In a process of continuous improvement, we have modified our spacers for P26, P40 and P100 systems.

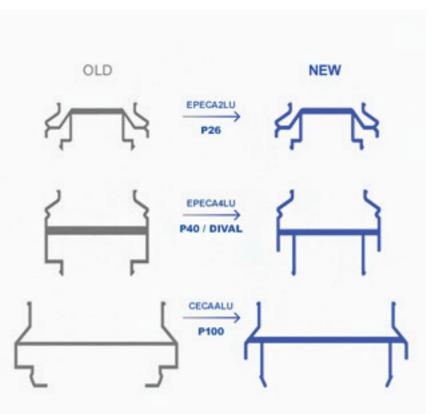
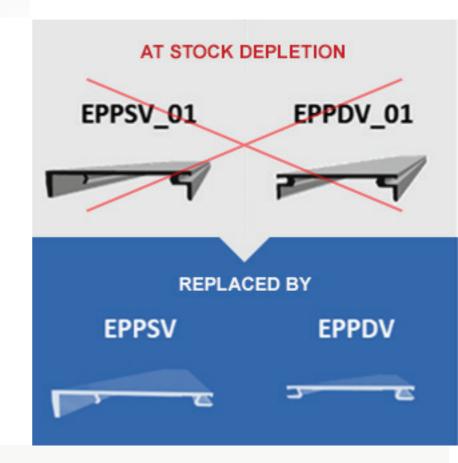
Improved clipping, ease of assembling / disassembling and durability are the main advantages of the new spacers.

The improvement of the spacers comes with a simplification of our glazing profiles: from now on, there will be only one aluminium glazing profile, whatever the glass thickness is (from 5 to 12mm) with matching glass seal. The "-01" profiles will be stopped when stock is cleared.

They will replace the current spacers when the latter are discontinued.
